Exhibit 29
SSDP2016-00415
004858

Thank you for submitting comments pursuant to the East Lake Sammamish Segment 2B Shoreline Substantial Development Permit (SSDP2016-00415). I am sorry to hear that there was difficulty in accessing some of the supporting information. I am recapping some of our previous communications in this letter, providing updated links to some of the files for review, and offering another opportunity to meet to go over all of the information.

EAST LAKE SAMMAMISH
MASTER PLAN TRAIL
SOUTH SAMMAMISH SEGMENT B
SAMMAMISH, WA

SHEET NO.
42 OF 135
AL10

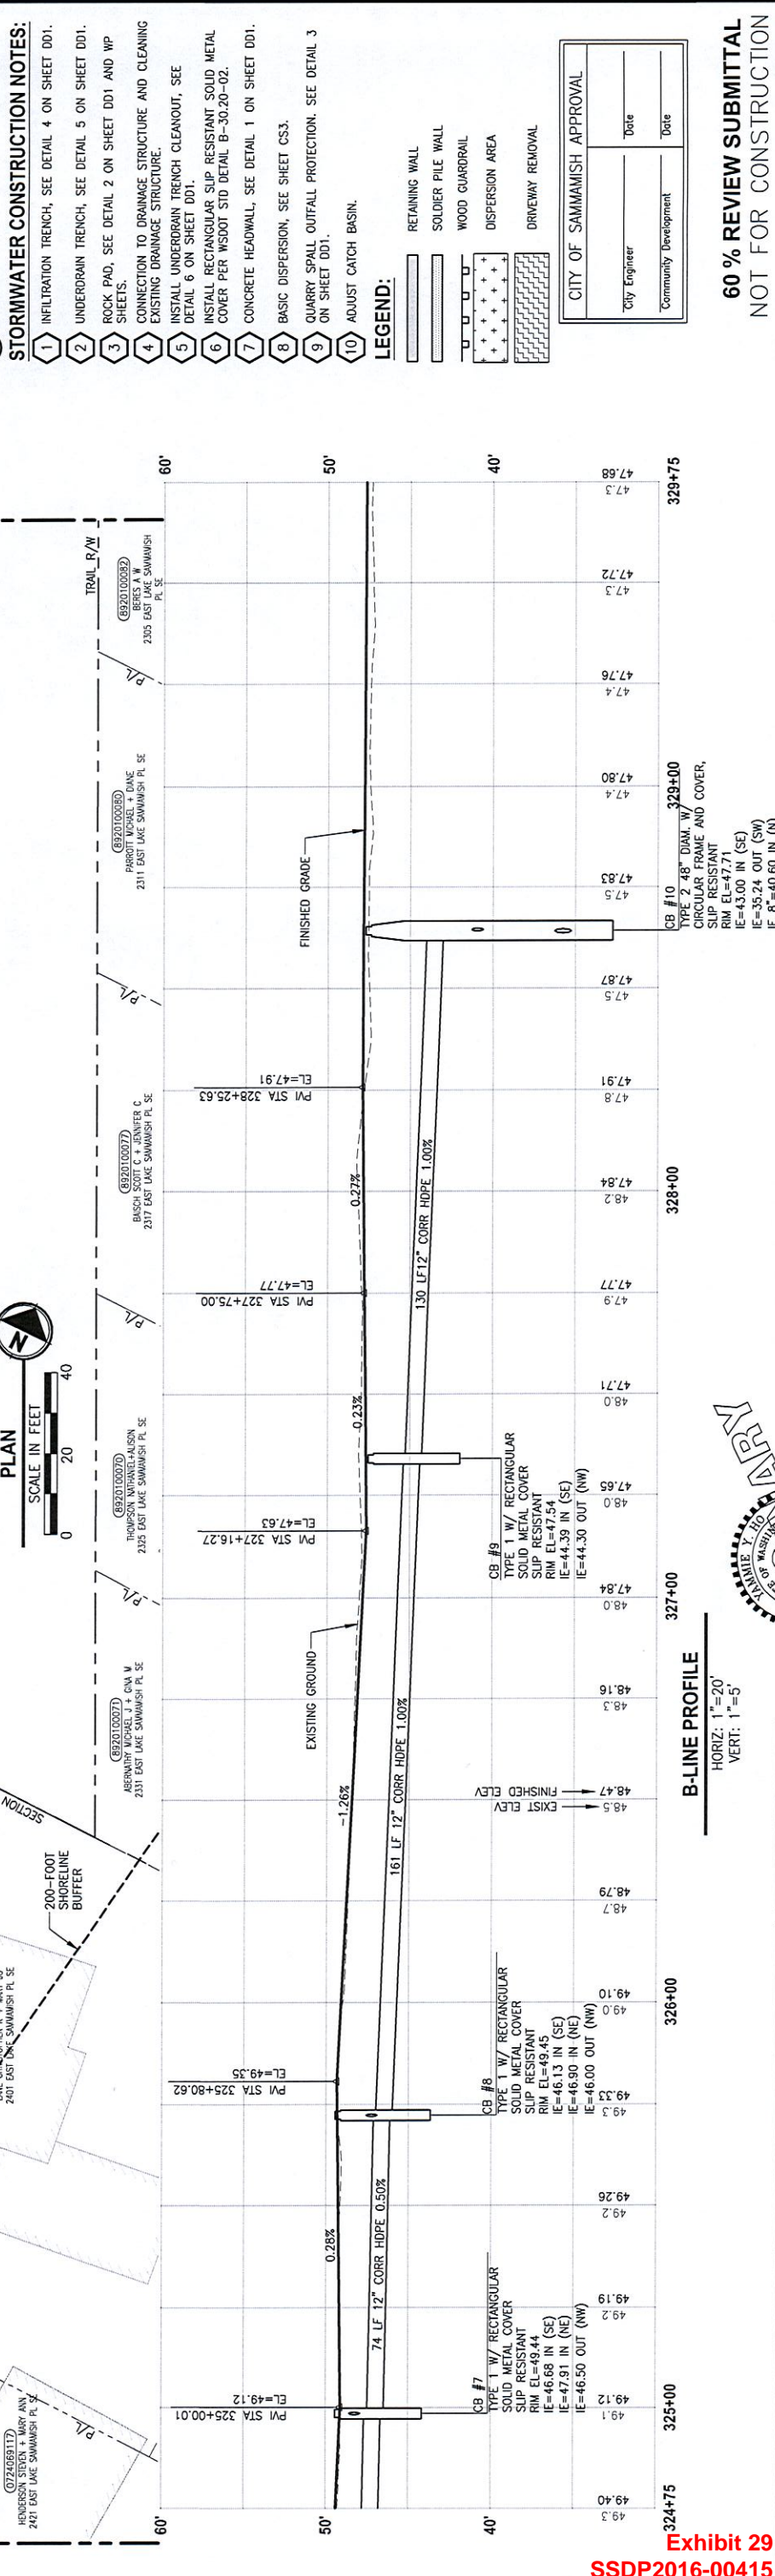
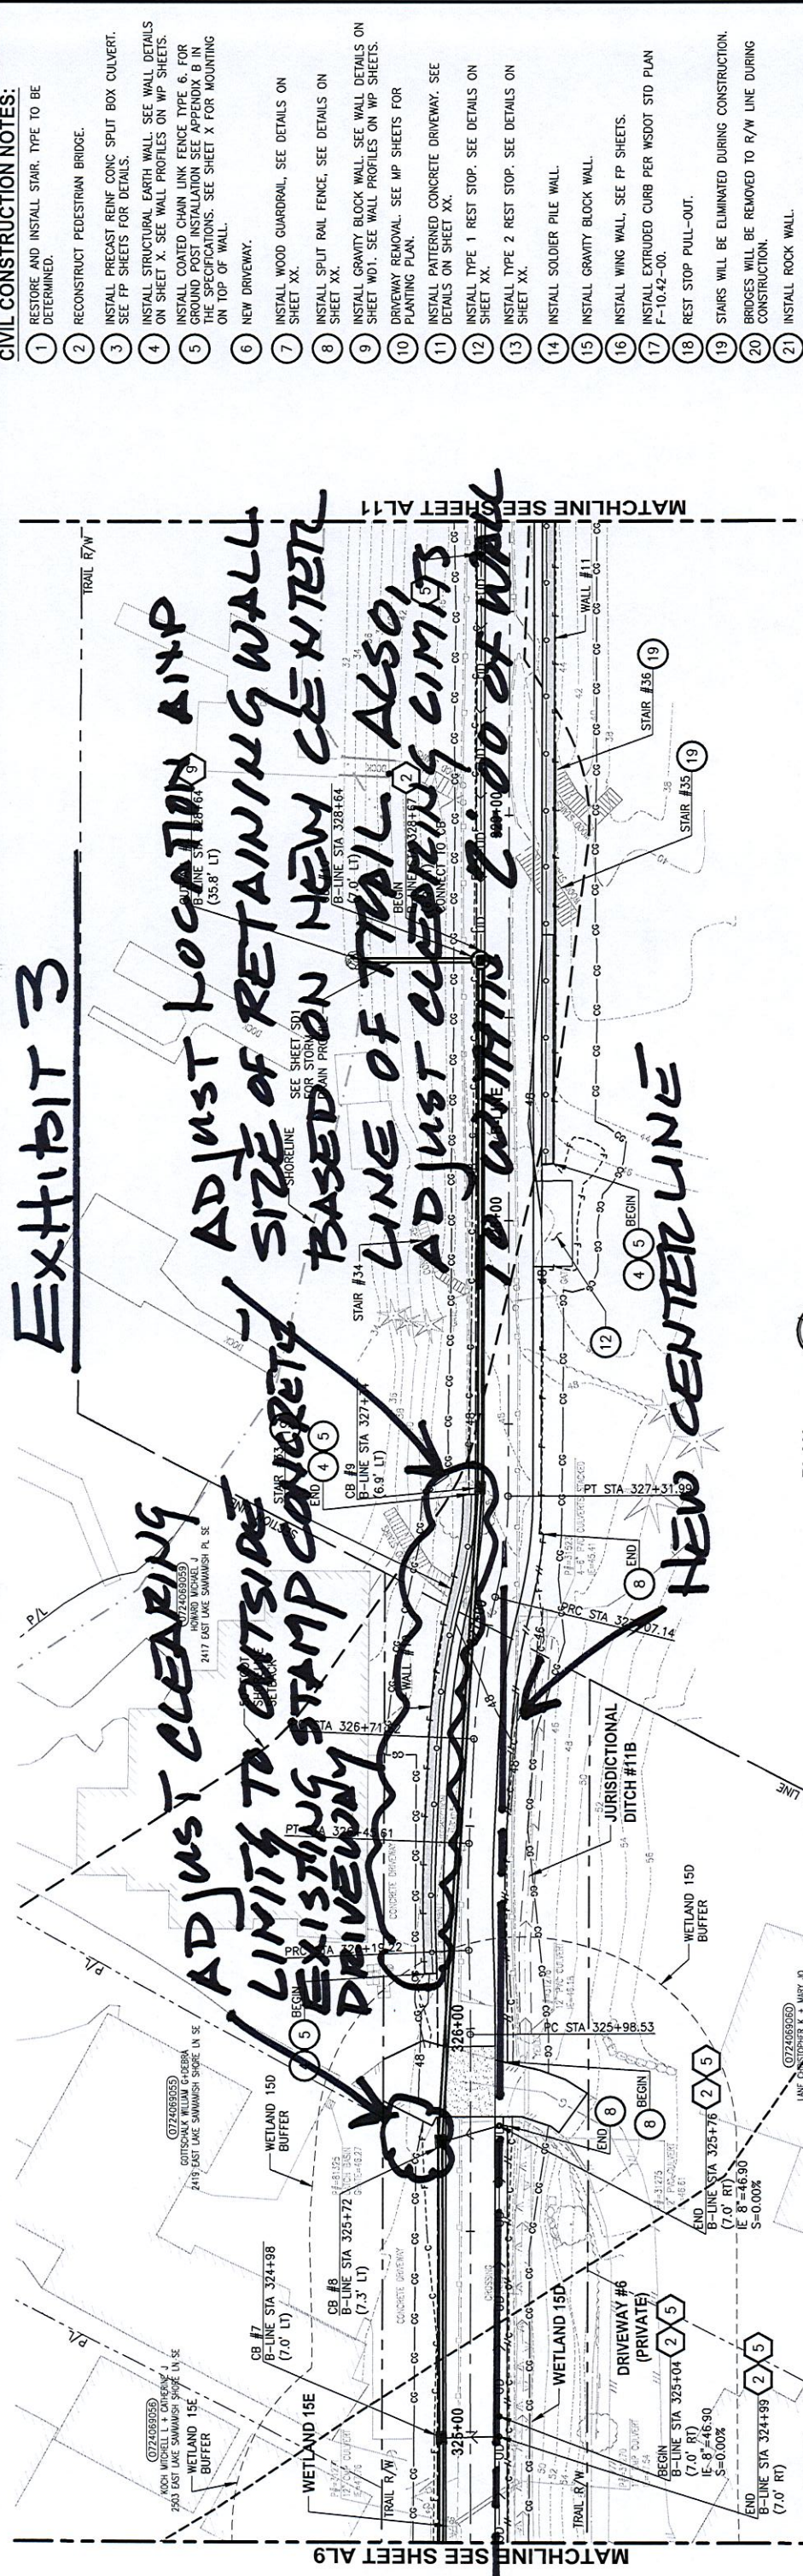
Per the Preliminary Plans, it appears that the County is unnecessarily realigning the centerline of the Trail waterward (*i.e.*, closer to my clients' residences).² Notably, the County has previously published the criteria that it employs to determine if the existing centerline of the Trail should be realigned, which include the following: (1) "[m]inimizing costs where possible without impacting trail standards," and (2) "[m]inimizing impacts to adjacent homeowners."³ As explained in greater detail below, it does not appear that the County's proposed realignment complies with either of these criteria.

The existing elevated Trail corridor currently acts as a berm that collects surface water behind it during extreme weather conditions. This problem is exacerbated by excess hydraulic water pressure from Jurisdictional Ditch #11B and runoff from nearby impervious surfaces, including the existing semi-permeable gravel Trail.⁵ Although the Preliminary Plans depict the existence of four, 6-inch culverts located near the north end of Jurisdictional Ditch #11B,⁶ these culverts do not currently provide an outlet for the ponding water. Instead, because the ponding water currently has no outlet, it builds hydraulic pressure that adversely affects the foundations and sewer systems of both the Gottschalk and Greve residences. This hydraulic pressure has led to water infiltration through the foundations and into their respective residences.

The proposed drainage improvements in the Preliminary Plans do not appear to adequately address these drainage concerns. In particular, changing the Trail from a semi-permeable gravel surface to an impervious paved surface, while simultaneously widening the Trail, will increase surface water runoff. Moreover, the Preliminary Plans do not depict any underdrain in the vicinity of my clients' properties that will allow for surface water collecting on the east side of the Trail to drain to the west side and ultimately be discharged into the Lake. In other words, it is likely that the existing ponding conditions will continue unless and until the Preliminary Plans are revised with respect to drainage.

- **Retaining Wall #10** – My clients' preferred alignment would allow for Retaining Wall #10 to be moved east, closer to the alignment of the Trail, which could then be reengineered to be either a smaller retaining wall, or be eliminated altogether as a result of existing elevations. This common sense change would result in considerable savings to taxpayers.⁸

- **Clearing and Grubbing Limits** – My clients also propose that the clearing and grubbing lines be modified to correspond to my clients' preferred Trail realignment. My clients' proposed modifications are depicted on the attached Exhibit 3. Further, the clearing limits should be adjusted to follow the course of the Trail in order to prevent and/or limit, any adverse impacts to my clients' existing stamped concrete driveway, irrigation, drainage, and landscape lighting.

PLAN AND PROFILE

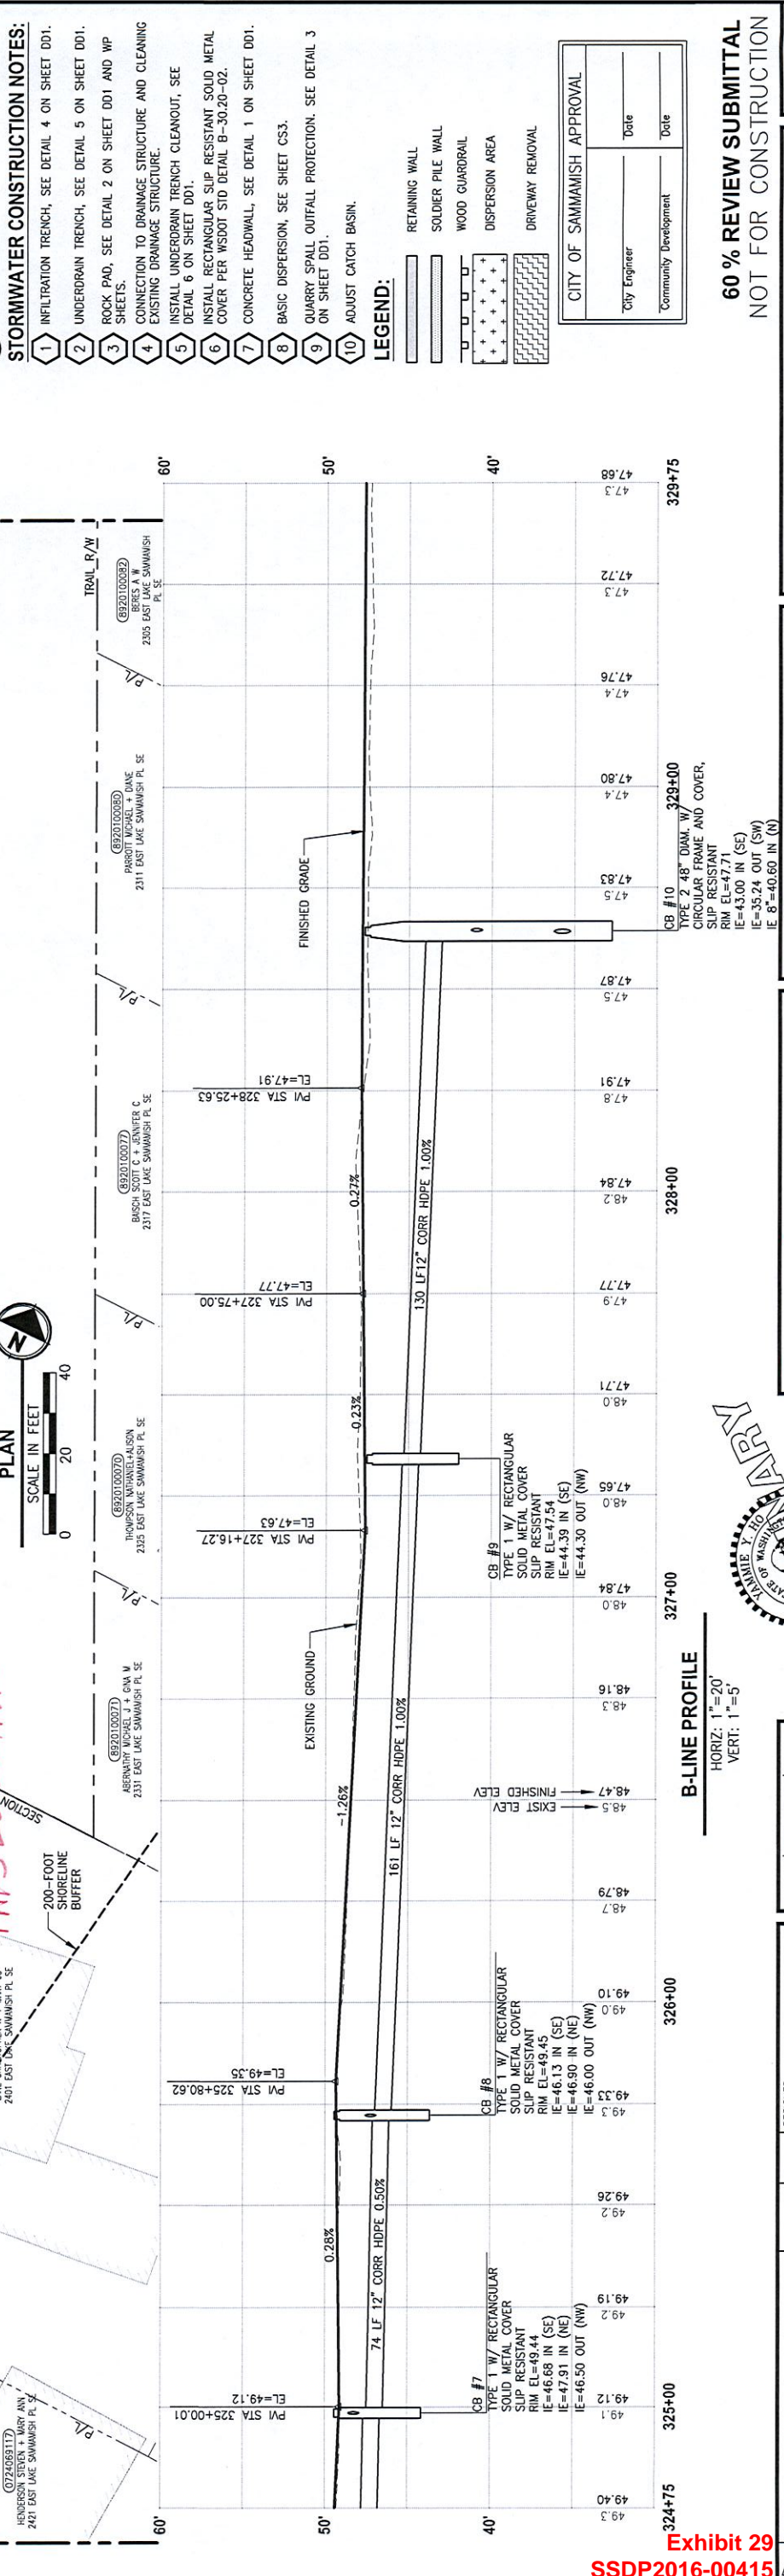
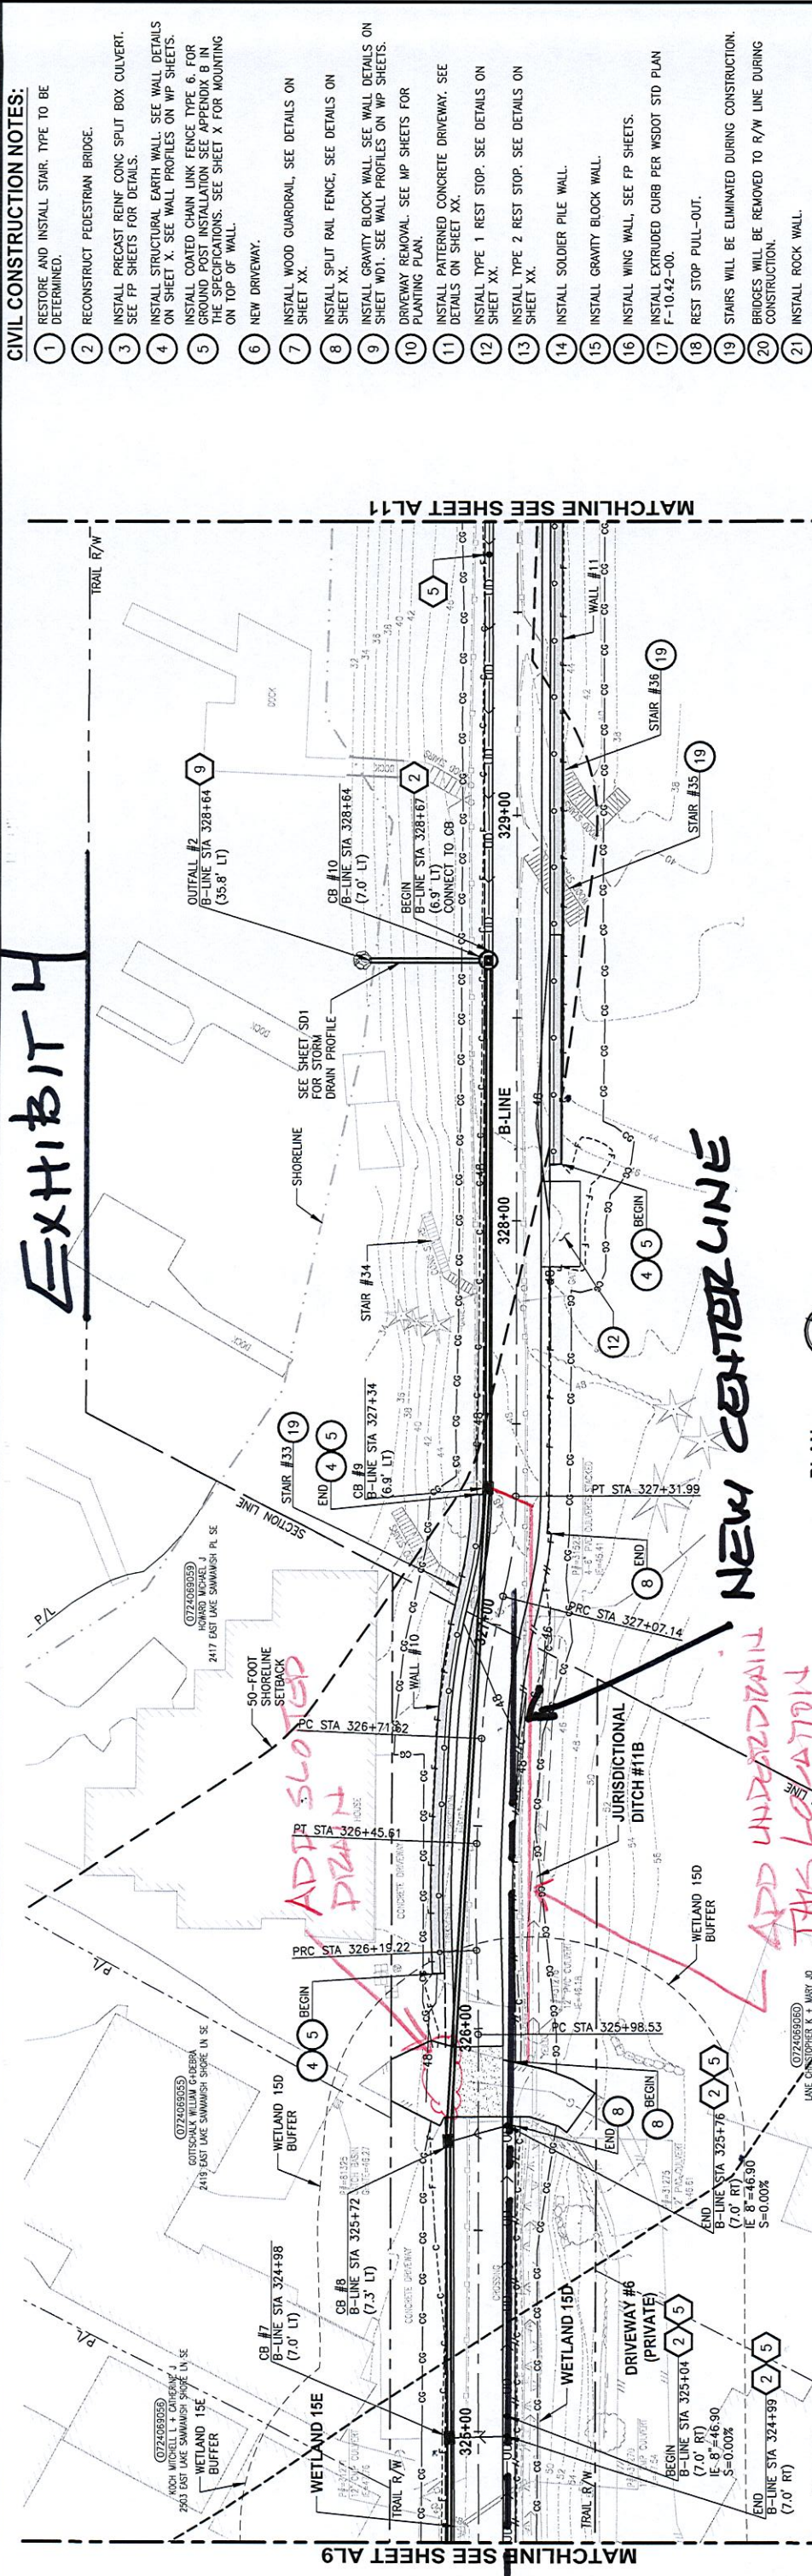
² Compare Preliminary Plans, Existing Conditions Plan, at pg. EX6 (attached hereto as Exhibit 2) with Plan and Profile, at pg. AL10 (attached hereto as Exhibit 1).

⁵ See Preliminary Plans, Existing Conditions Plan, at pg. EX6 (attached hereto as Exhibit 2) with Plan and Profile, pg. AL10 (attached hereto as Exhibit 3).
